# The Repowered and Extended Ben Aketil Wind Farm

Additional Information

Design Amendments and Updated Environmental Information

663617

**Figure 1: Re-designed track leading to T08 (blue polyline)**

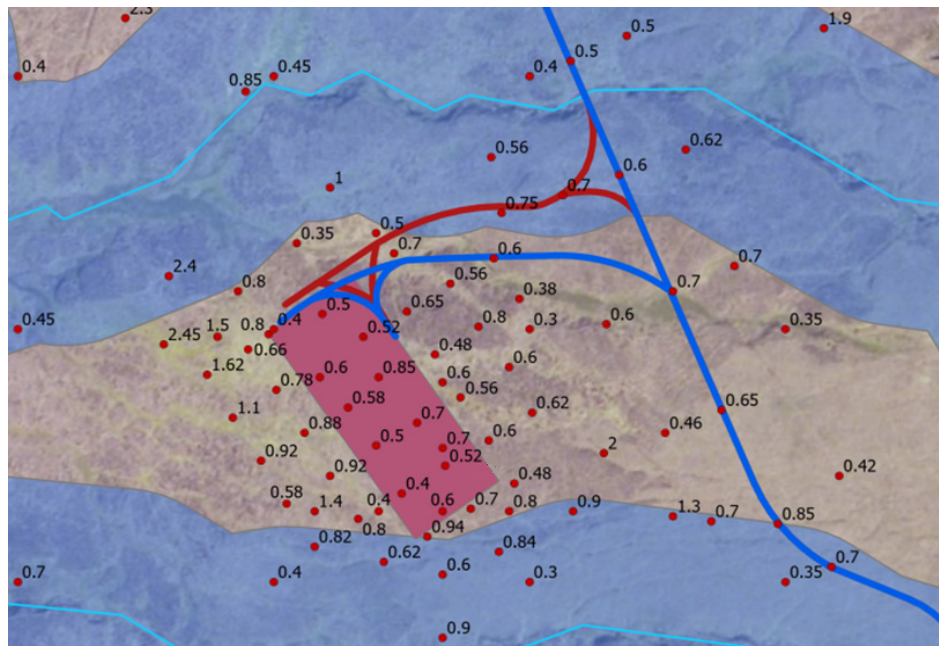
- 3.8 *'We note that the track associated with Turbine 5 encroaches well into the 50m buffer, this track should be moved outwith the buffer unless it is justified and balanced against other sensitive receptors. As we have also raised concerns with the volume of peat excavation associated with the new track to T5 (Section 1.3 of response dated 25 August 2023) it may be that significant changes to the layout are required to ensure there are no unacceptable impacts on both peat and watercourses. This is also true of the track associated with Turbine 8 and the track leading to the construction compound.'*

- 3.14 As requested, the track route leading to T08 has been re-designed to avoid development within the watercourse buffer. The re-designed track is shown in Figure 1 overleaf, and **Figures 1.1** and **3.1**.
